**HISTORIC LANDMARK COMMISSION
AUGUST 22, 2011
PERMITS IN NATIONAL REGISTER HISTORIC DISTRICTS
NRD-2011-0070
2530 Harris Boulevard
Old West Austin**

Construct a second-story addition to a 1-story single-family home, remodel 1-story, detached “back house” building at rear, demolish existing carport and construct a new carport.

STAFF COMMENTS

STAFF RECOMMENDATION

ELEVATIONS

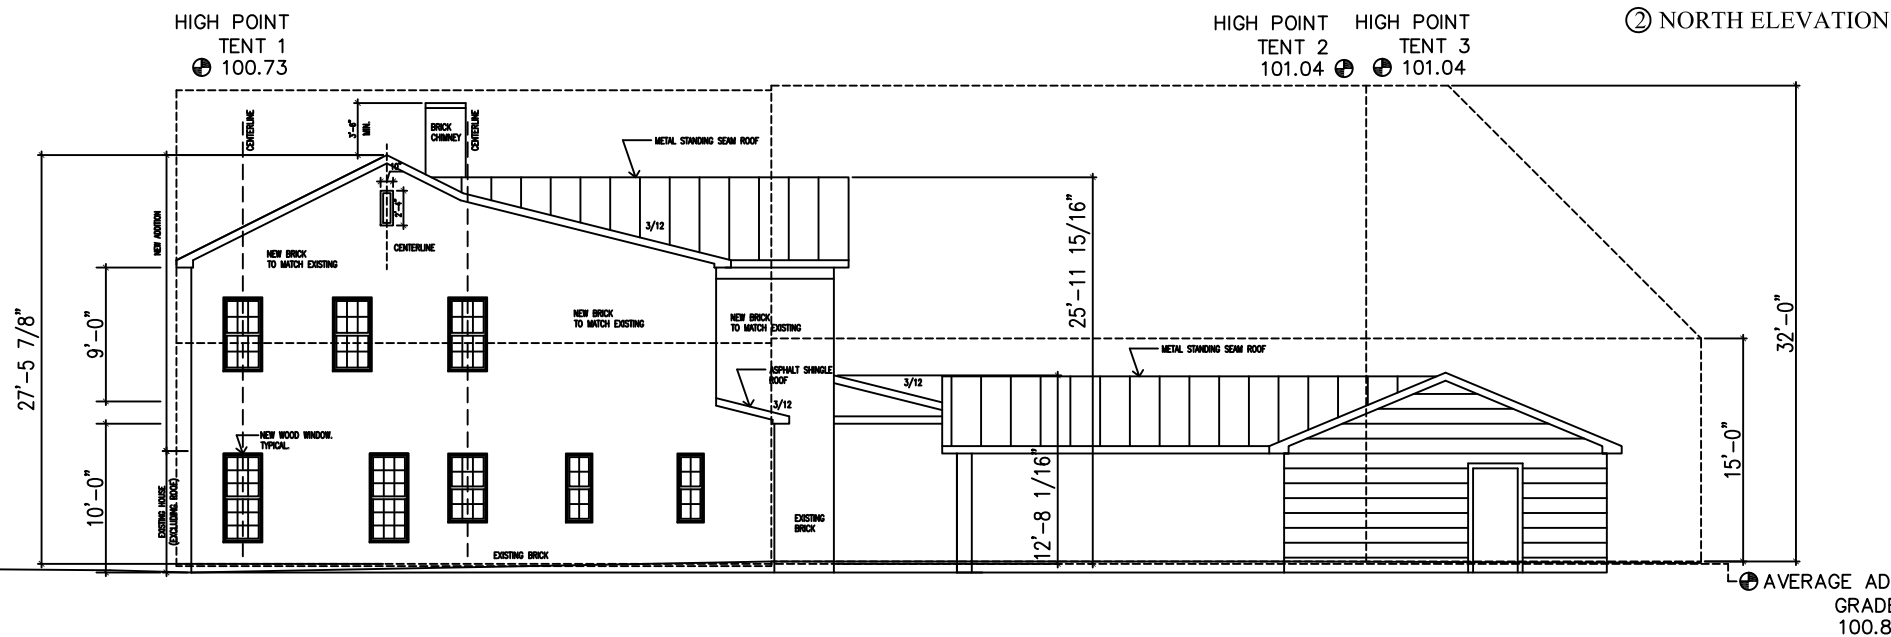
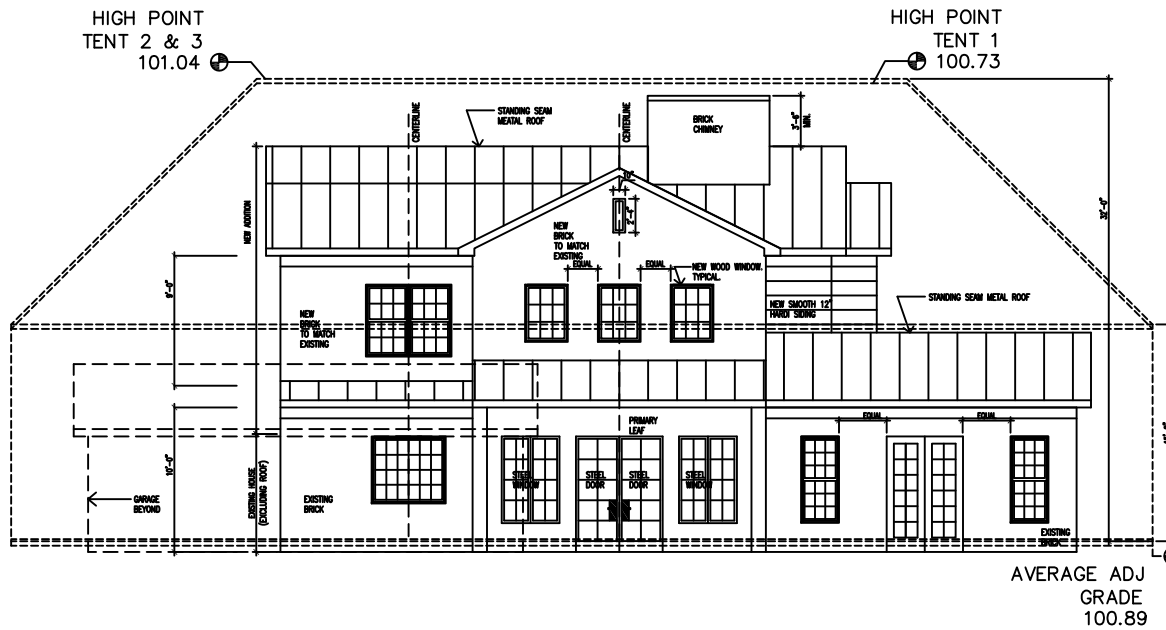
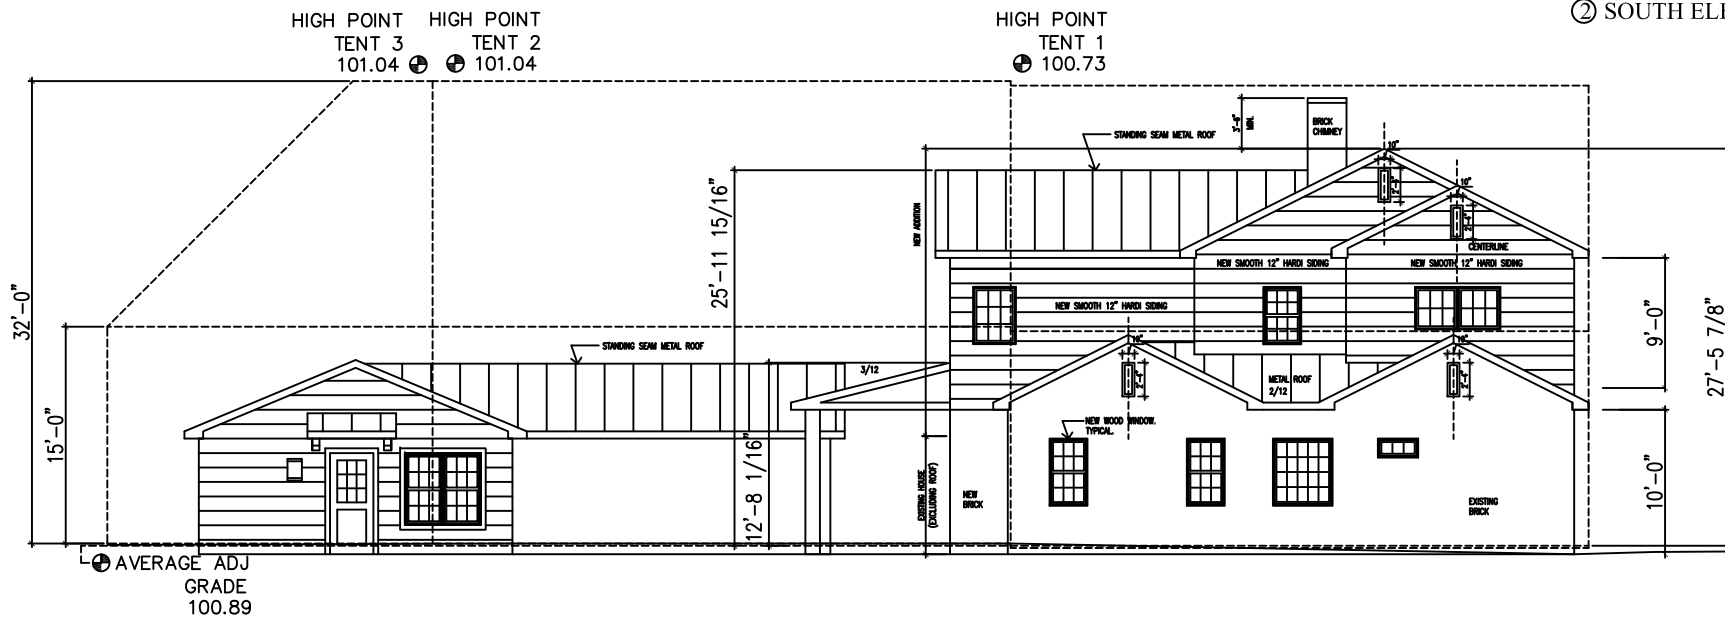
The project as proposed is compatible with other properties in the district in terms of size, scale, material and character. Staff recommends approving the project as proposed, however recommends the applicant consider using composition shingles in lieu of standing metal seam roofing as would be more appropriate for a Neocolonial-style house.
